**CURATIVE AMMENDMENT FOR APPLICATION FOR
LICENSE (302-AM)**

WVOZ-AM AGUADILLA, PUERTO RICO

BL-20180911ADH (CP:BP-20170327AAF)

Changes made to EE -Proof of Performance:

Oct. 5/2018 (Curative Amendment)

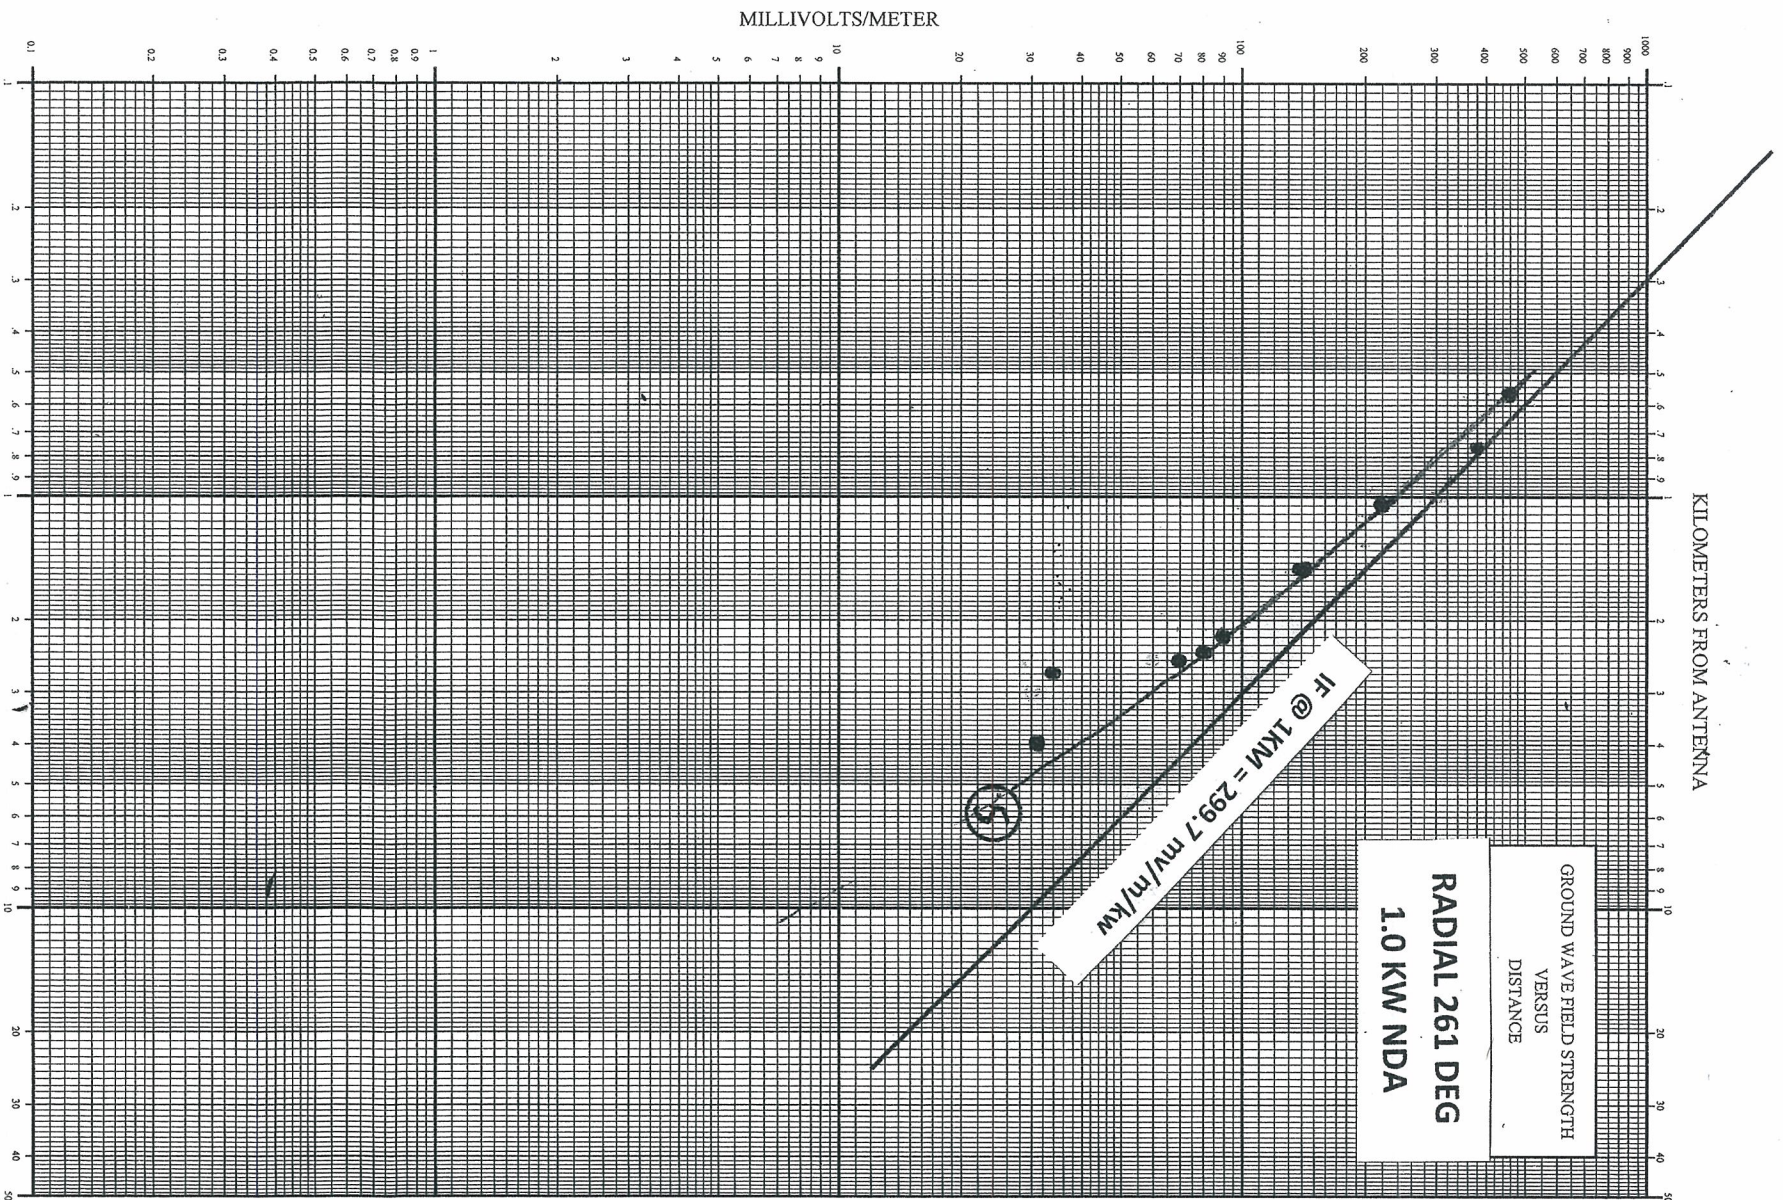
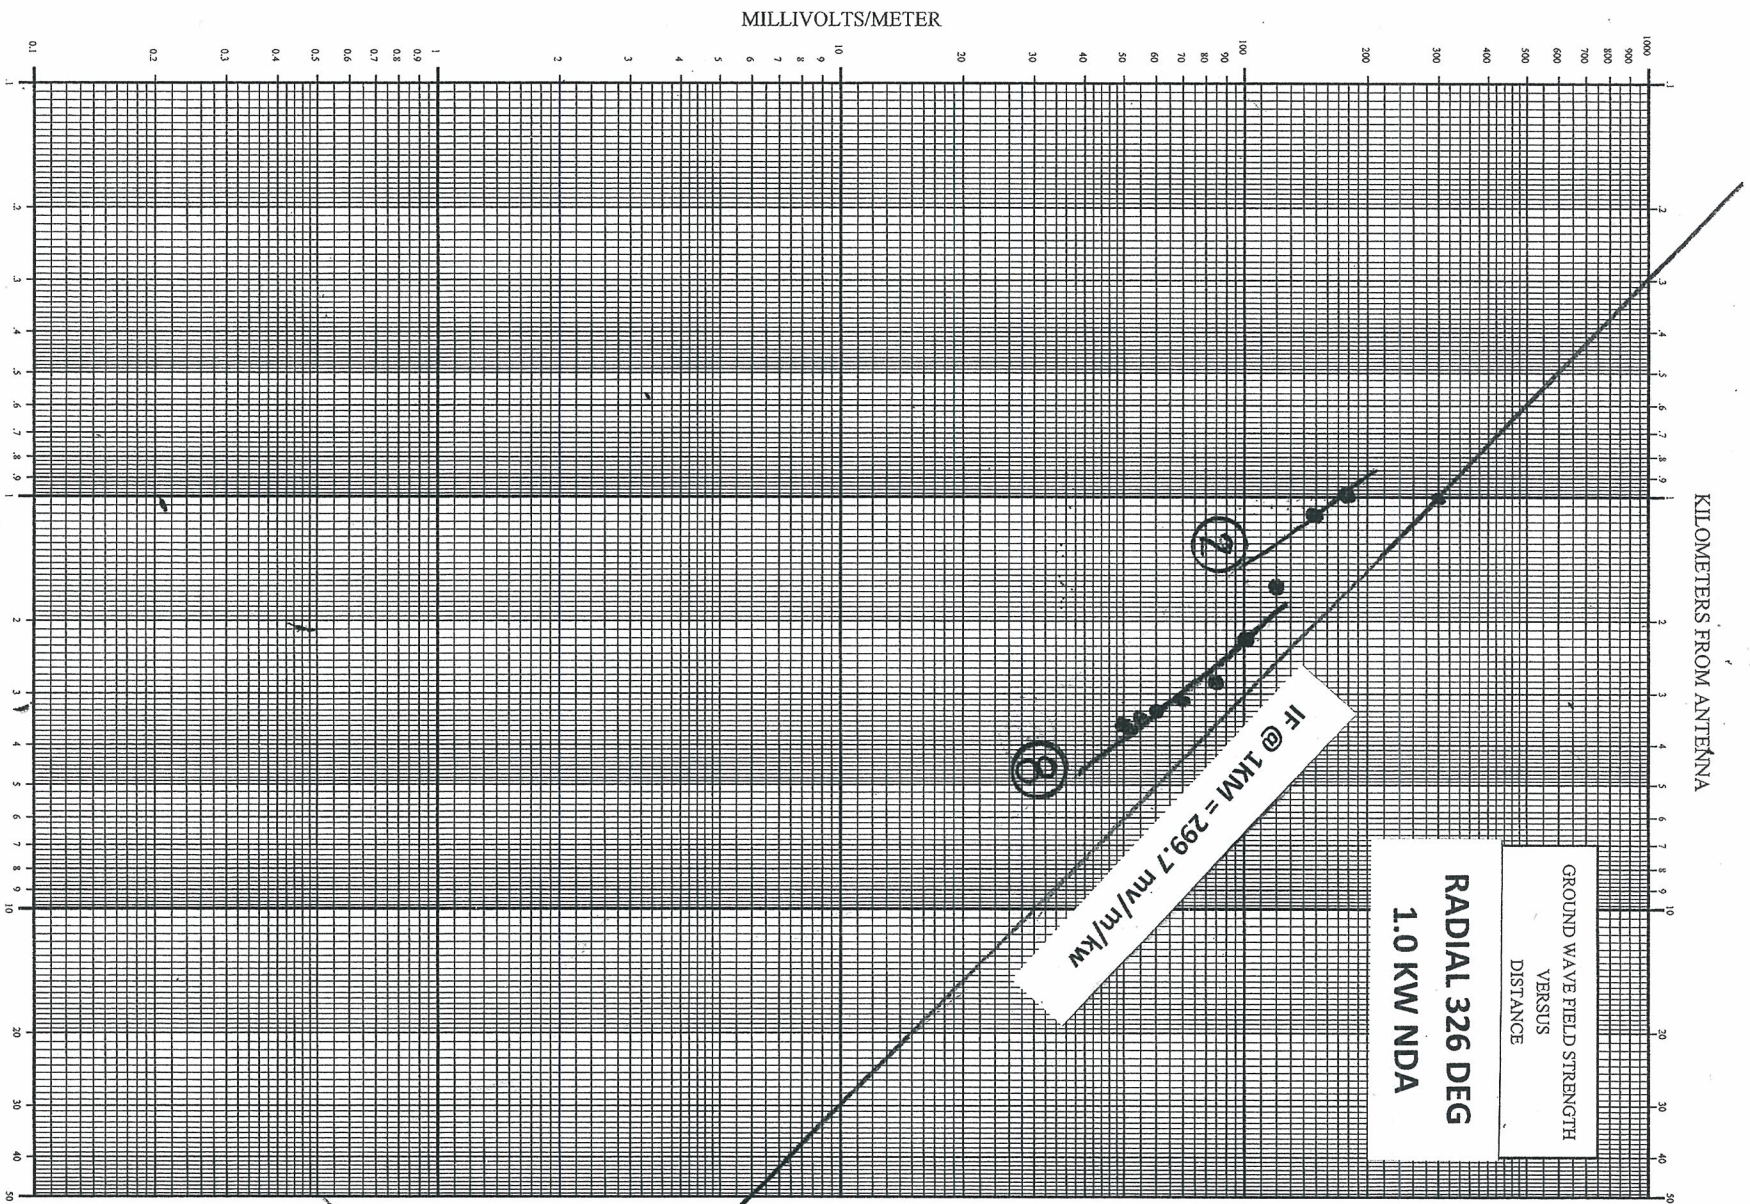
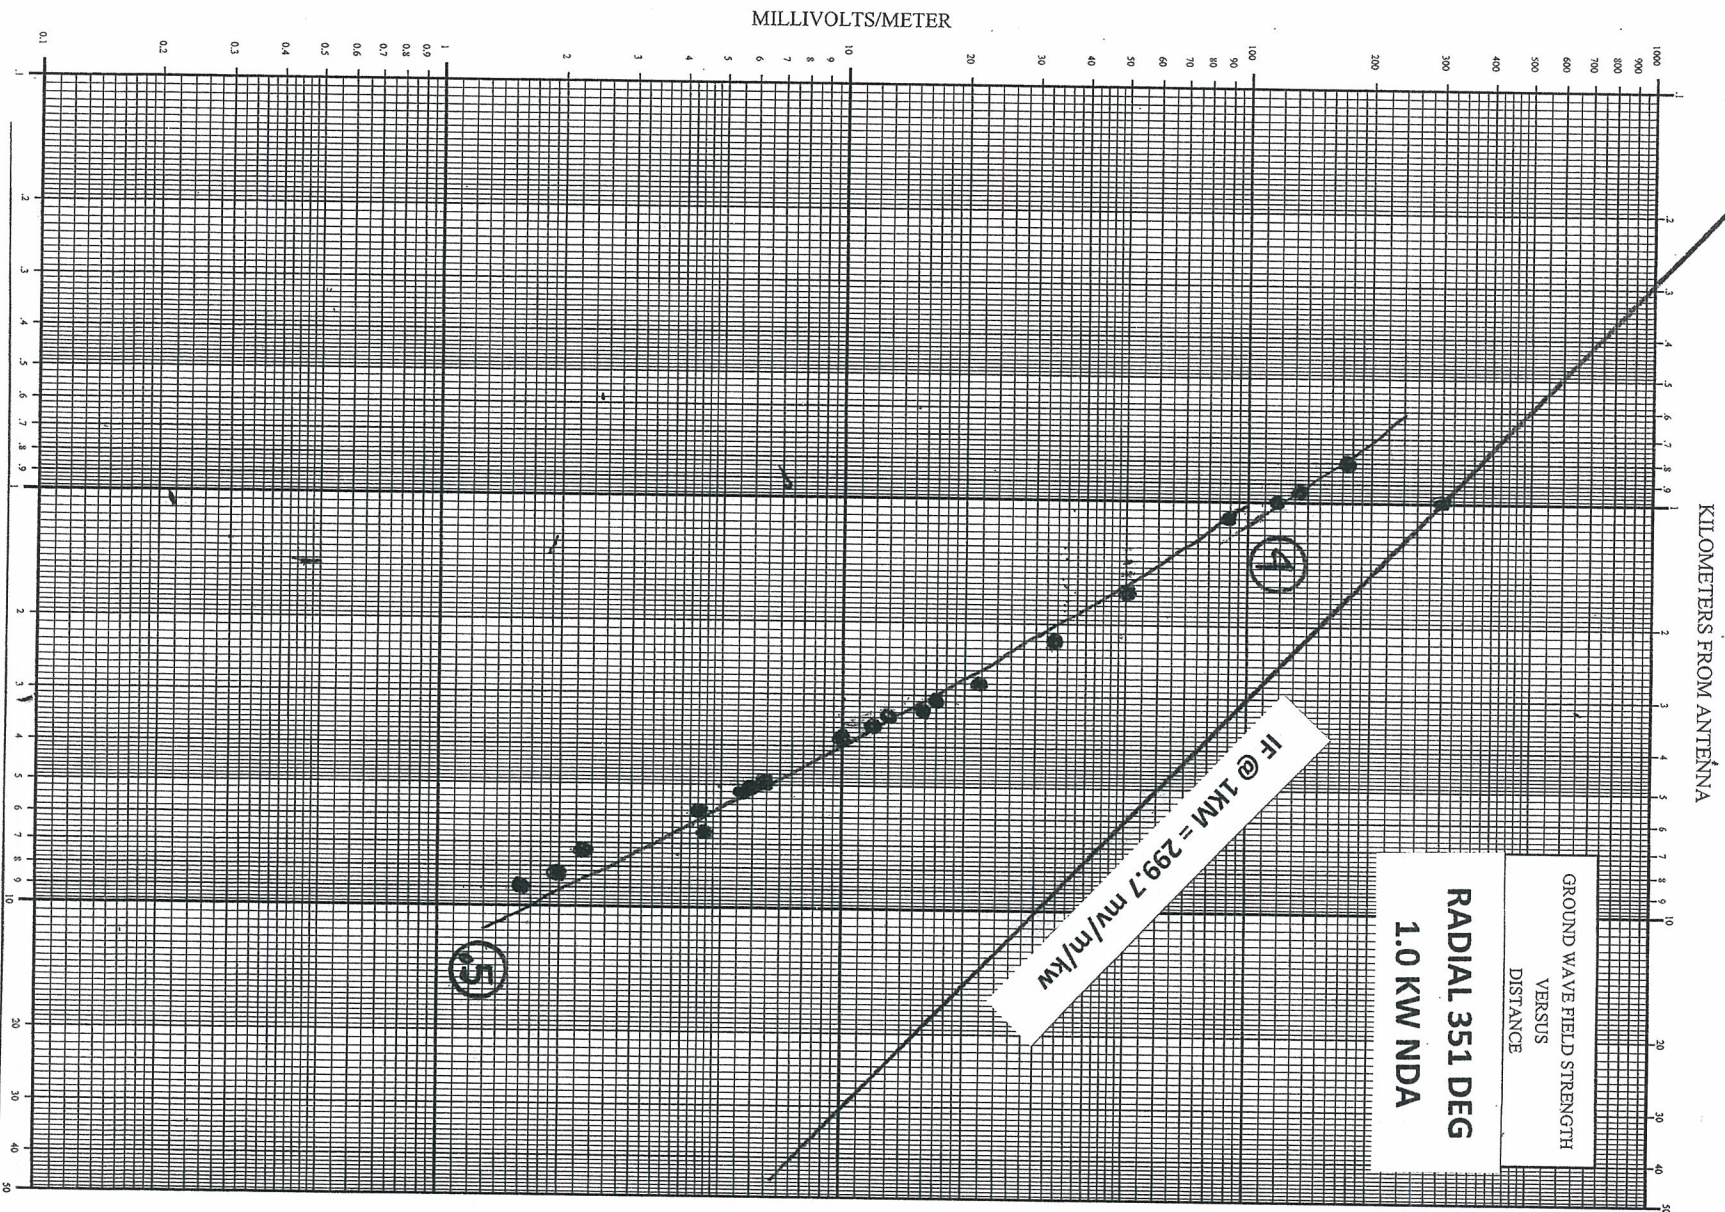
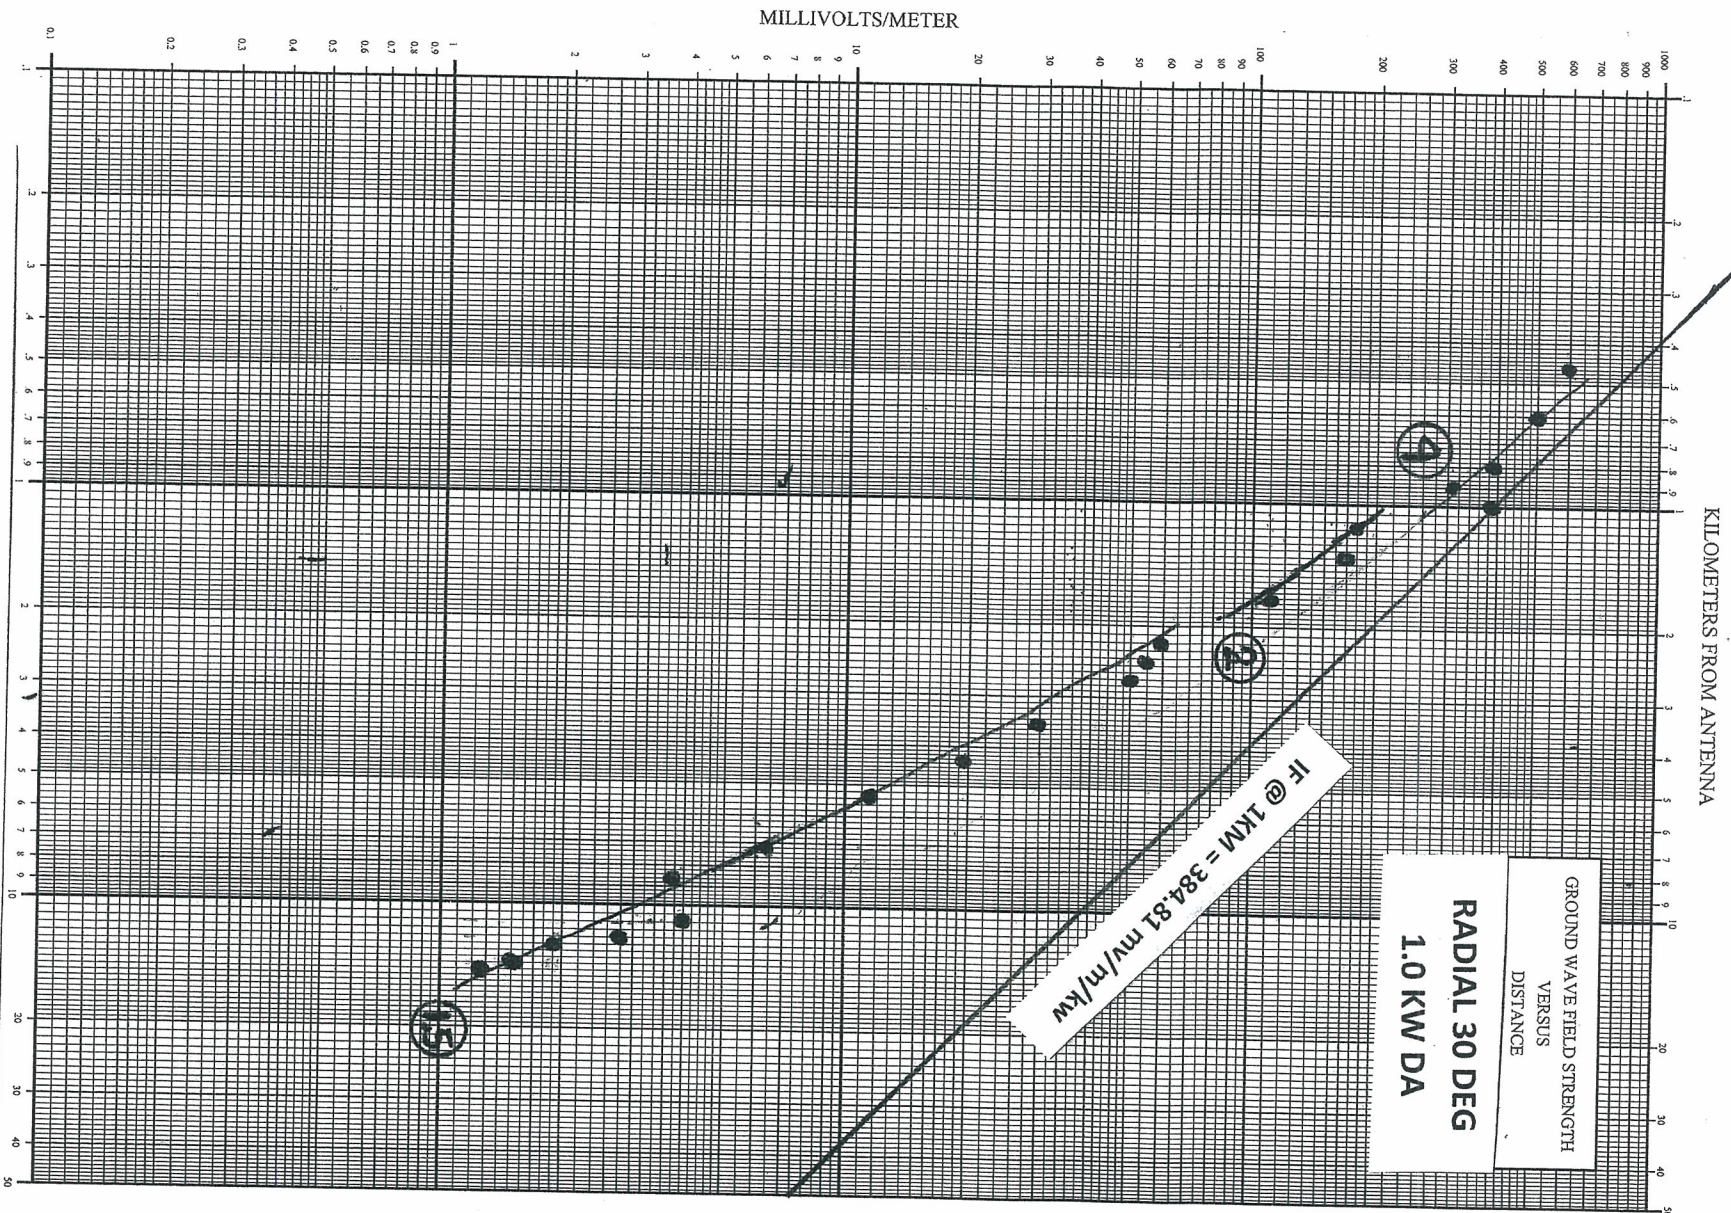
#1: By mistake, the secretary included as Figure 4 the incorrect set of graphs. The graphs that were included were an analysis tool and not the final graphs. The graphs incorrectly sent were used during the analysis process to figure out what the value for the points measured should most likely be after figuring out the attenuation curves by the best-fit method. That information was used to measure again most of the points that didn't fit on the conductivity curves selected for each radial to ensure the measurements originally taken were correct and that no error was made finding the correct point location and/or when taking the measurements.

The correct set of graphs is included for non-directional and directional. As you will see the conductivity curves chosen by the best-fit method are basically the same as the ones incorrectly sent. Although the email containing the PDF to the FCC was sent on Sept. 6/2018 and that same day the FCC emails back to us with the deficiencies, the paper filed copy was exactly the same as the one sent by email, since a curative amendment was immediately required by the FCC.

By this means, it is respectfully requested that the correct set of graphs along with the family of curves used to analyze them be made part of this curative amendment. (Please substitute the new set of graphs for each radial and insert Fig. 1 (Sheet 5A of 12: Family of curves for 1520-1600 downloaded from FCC page).
